**H.6 Approve Change Order Summary Report – May 2020**

**CHIPPEWA VALLEY SCHOOLS  
2018 Bond Issue Program**

**CHANGE ORDER SUMMARY #4  
May 2020**

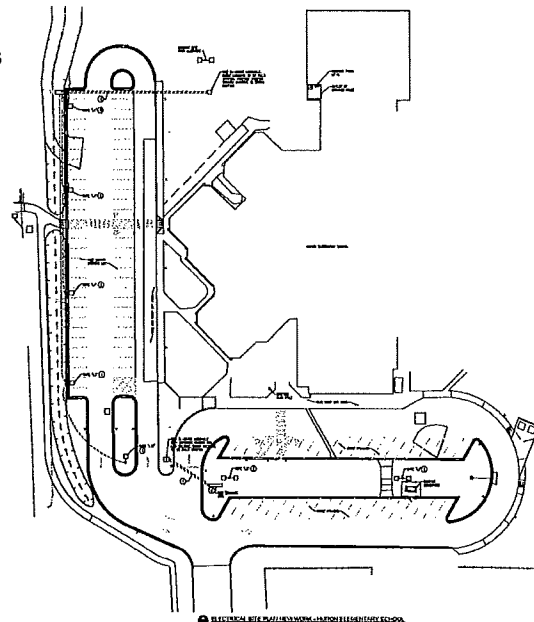
The original awards for bid pack 2C for Huron parking lot did not include pricing for the electrical work included in Addendum 1 to improve the light poles in the Huron parking lot and the electrical wiring for new school sign. We did not receive any qualified bids to complete this work originally. With COVID-19 delaying bidding for this work, we solicited and received estimates from 3 current qualified contractors to complete this work. To avoid delays in completing the paving project at Huron Elementary stemming from the Covid-19 epidemic, we recommend proceeding with Shoreview's estimate and not going for a full bid process for this work as it must be started before paving can begin. This work will be funded from the 2018 Bond Issue project base budget.

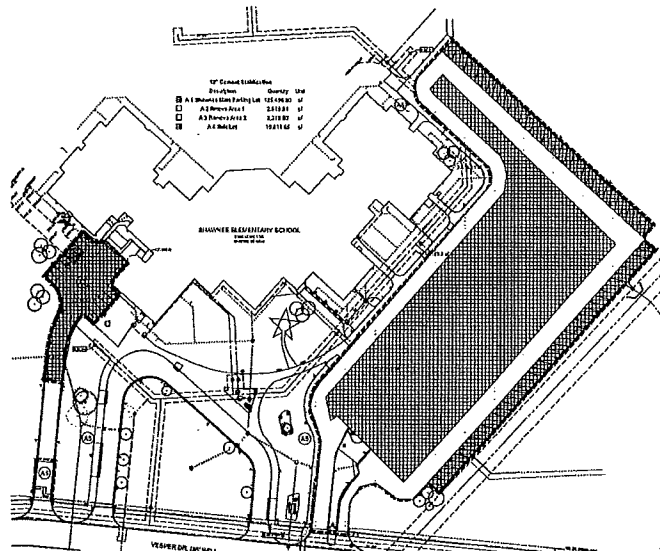
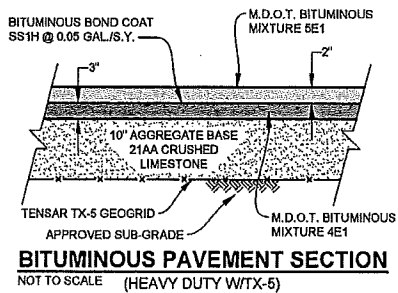
The bid documents did not include replacing the clay subgrade under the parking lot. After removing the asphalt, the subgrade was deemed by the testing engineer to be in need of significant reconstruction after proof roll was completed. The engineer recommended 2 options to address. After review with the civil engineer, the lime stabilization was recommended because it provides a better and higher degree of confidence that it will work. Additionally, this will alleviate having to do a full replacement project in the future like we are doing now, which will extend the useful life of the parking lot and save funds in the long term. The contract had provided unit pricing and will provide time tickets. This work will be funded from the 2018 Bond Issue project contingency fund.

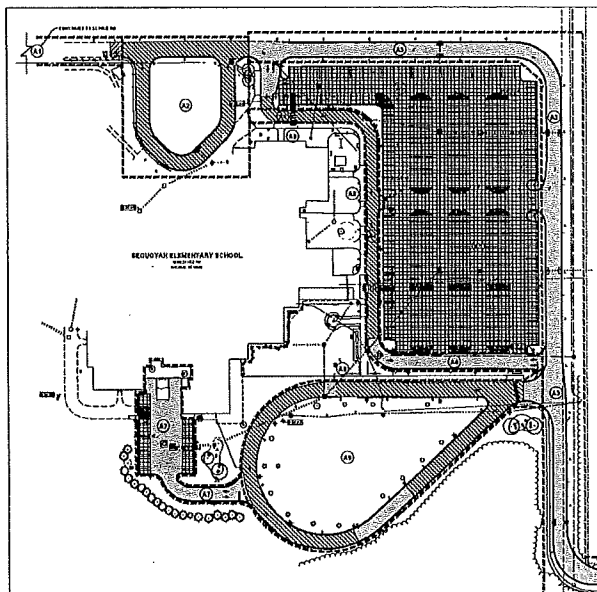
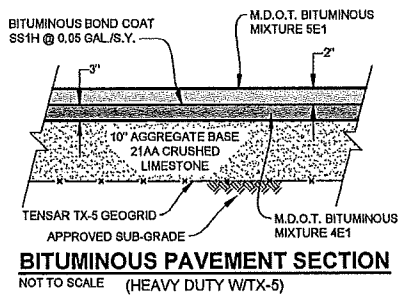
The bid documents did not include replacing the subgrade under the parking lot. After removing the asphalt, the subgrade was deemed by the testing engineer to be in need of reconstruction after proof roll was completed. The contract had provided unit pricing and time tickets will be provided. This work will be funded with the \$20,000 contracted allowance and the remainder from the 2018 Bond Issue project contingency fund.

**A** EXISTING FRAME DETAIL  
NO SCALE

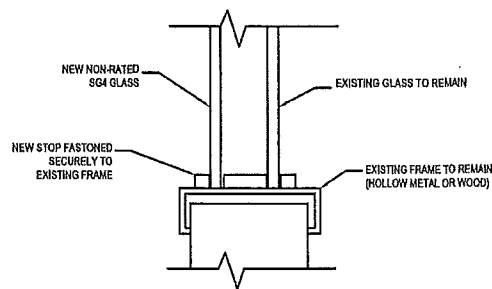
The original bid documents included replacing the existing fire-rated glass new combination fire-rated / security glass. After further review a more suitable solution was to leave the existing fire-rated glass in place and add security rated glass to the existing framing. This solution provides the required security and fire safety measures while being more cost effective than fully replacing the glass. The State Office of Fire Safety has also reviewed and approved this solution.
